# Office Action Summary

09/418,902

KLEMP ET AL.

## DETAILED ACTION

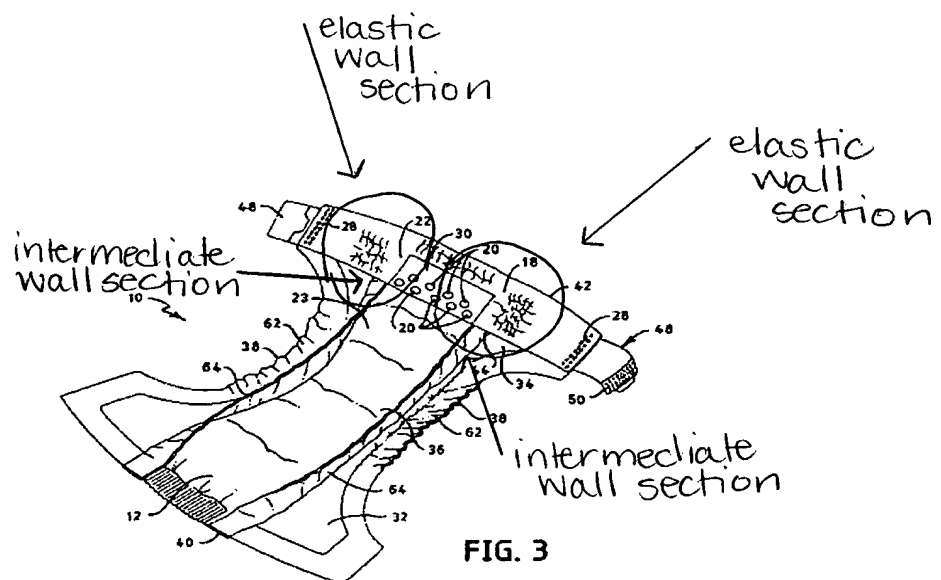
With respect to claim 1, Turner et al (hereinafter referred to as Turner), teaches a disposable absorbent article having side and end edges (10), a topsheet layer (12), a backsheet layer (14), an absorbent core (16), and at least one end strip (18, 19) as shown below:

Turner discloses the first section having generally elastic properties (col. 9, lines 42 – 43), and the second section can be understood to be substantially less elastic than the first section since the second section includes apertures (page 11 of the applicant's specification). Additionally, Turner teaches the third section being spaced away from the topsheet and core as set forth in col. 4, lines 65 – 66.
